Square Fashion Ltd. #10266

Chandra, Basan Union, Gazipur

Identified Priority 1 Concerns

1st Priority 1 Concern

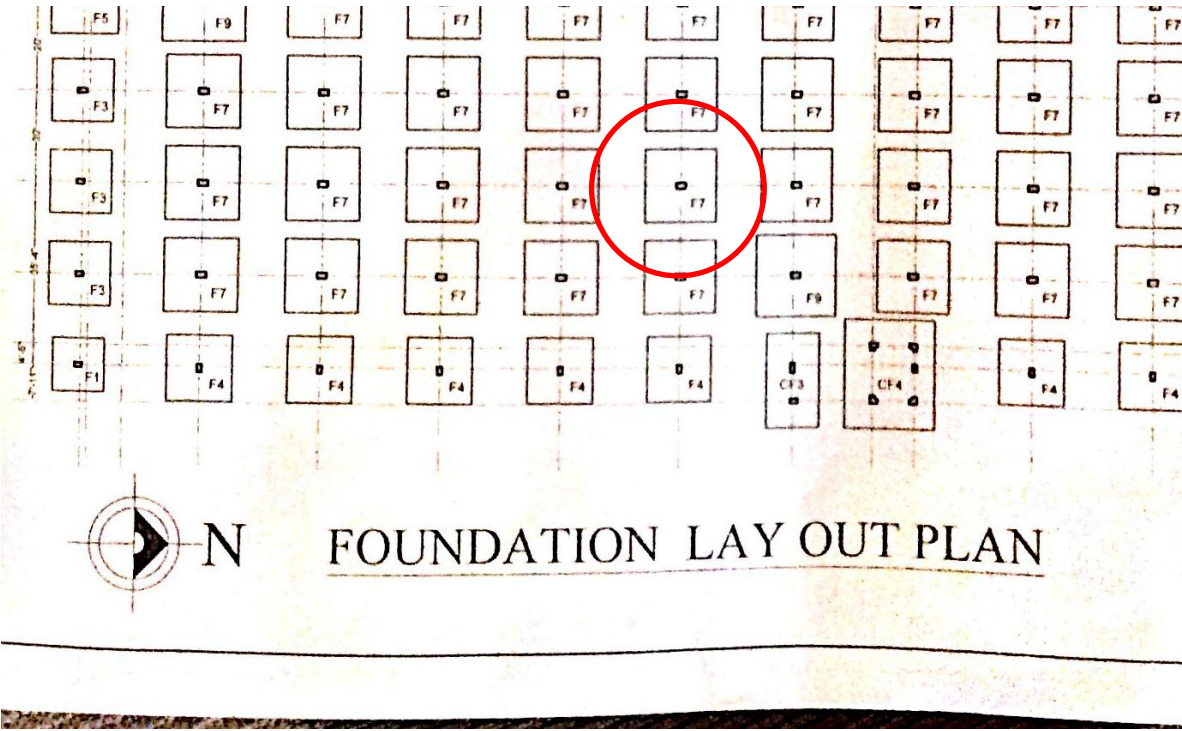
A 15" raised platform was discovered on the 1st floor, which is not shown on the structural drawings.

The raised platform is comprised of brick walls, sand infill, 4" concrete slab, screed and tile.

Item No.	Observation	Recommended Action Plan	Recommended Timeline
1	A 15” raised platform was discovered on the 1st floor, which is not shown on the structural drawings, nor is it accounted for in the loading plans provided.	Remove raised platform in its entirety.	Immediate – Now
2	A steel roof on the 6th floor slab is not shown on the structural drawings, nor is it accounted for in the loading plans provided.	Review as built conditions on roof slab and update structural drawings.	Immediate – Now
3	A steel roof on the 6th floor slab is not shown on the structural drawings, nor is it accounted for in the loading plans provided.	Review permissible loading with design and engineer and produce approved loading plans. Display & manage loading plans on all floors	6-weeks
4	No footing dimensions were found on structural drawings, and column reinforcing did not match structural drawings.	Review as built conditions on and update structural drawings.	Immediate – Now
